SCHILLINGERS COMMERCE PLACE SUBDIVISION, RESUBDIVISION OF LOT 1 SUBDIVISION

APPLICATION NUMBER 6 DATE January 20, 2022

DETAIL SITE PLAN

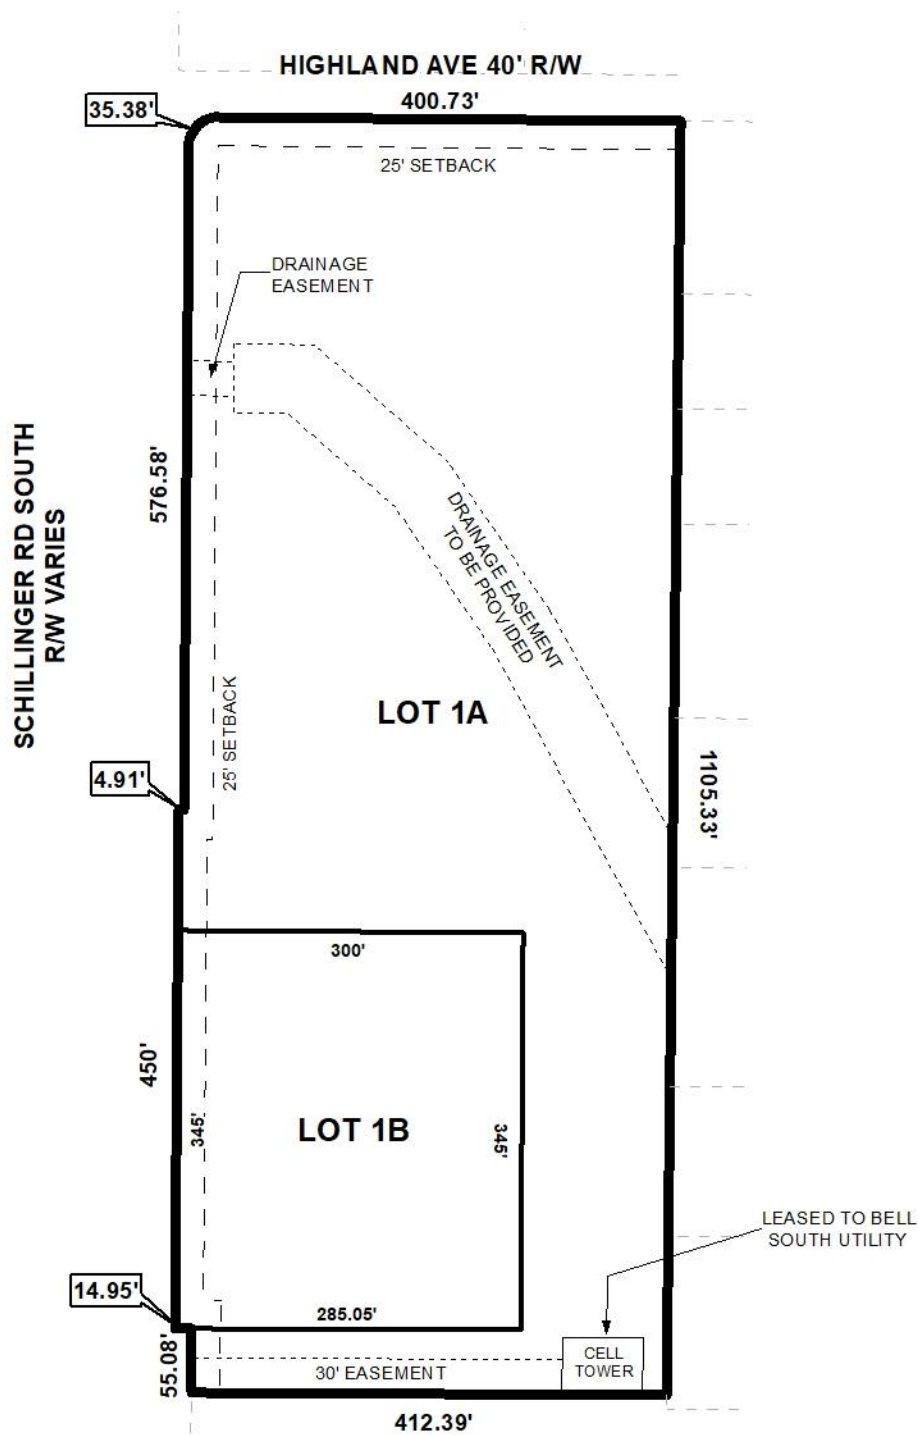
The site has frontage on Schillinger Road South and Highland Avenue. Schillinger Road South is a major street on the Major Street Plan, and as such should have a 100-foot right-of-way. The preliminary plat shows that there is a minimum of 55-feet from the front property line to the centerline, making no dedication necessary. Highland Avenue is a minor street with curb and gutter, and should therefore have a 50-foot right-of-way. The 2013 plat for the site depicts that there is more than 25-feet between the subject site and the centerline along Highland Avenue. If approved, the Final Plat should be revised to depict the distance to the centerline.

The preliminary plat depicts the 25-foot minimum building setback line along both frontages. If approved, this should be retained on the Final Plat.

The proposed lots meet the minimum size requirements of the Subdivision Regulations. As on the preliminary plat, the lot size labels in both square feet and acres should be retained on the Final Plat, or a table should be furnished on the Final Plat providing the same information.

There is a 30' wide drainage easement depicted for Lot 1A, with a note that the width and location of the easement are to be determined at the time the lot is developed. However, as easements must be recorded in a way to insure there are no structures erected in them, this note should be removed, and a note should be placed on the Final Plat, if approved, stating that no structures shall be erected in any easements without the permission of the easement holder.

The site is located along the City-County border with properties to the rear being in the County with a mix of residential use and vacant land. Therefore, a note should be placed on the Final Plat stating that a buffer, in compliance with Section V.A.8. of the Subdivision Regulations must be provided where the site adjoins any residential use.

- 1) retention of the right-of-way width, and distance to the centerline of Schillinger Road South on the Final Plat;
- 2) retention of the right-of-way width, and provision of the distance to the centerline of Highland Avenue on the Final Plat;

- 3) retention of the 25-foot minimum building setback line along all frontages on the Final Plat;
- 4) retention of the lot size labels in both square feet and acres on the Final Plat, or the furnishing of a table on the Final Plat providing the same information;

- 5) removal of the note stating that the width and location of the 30' drainage easement is to be determined at the time of development of Lot 1A;
- 6) placement of a note on the Final Plat stating that no structures are allowed in any easement without the permission of the easement holder;

- 7) placement of a note on the Final Plat stating that a buffer, in compliance with Section V.A.8. of the Subdivision Regulations must be provided where the site adjoins any residential use;
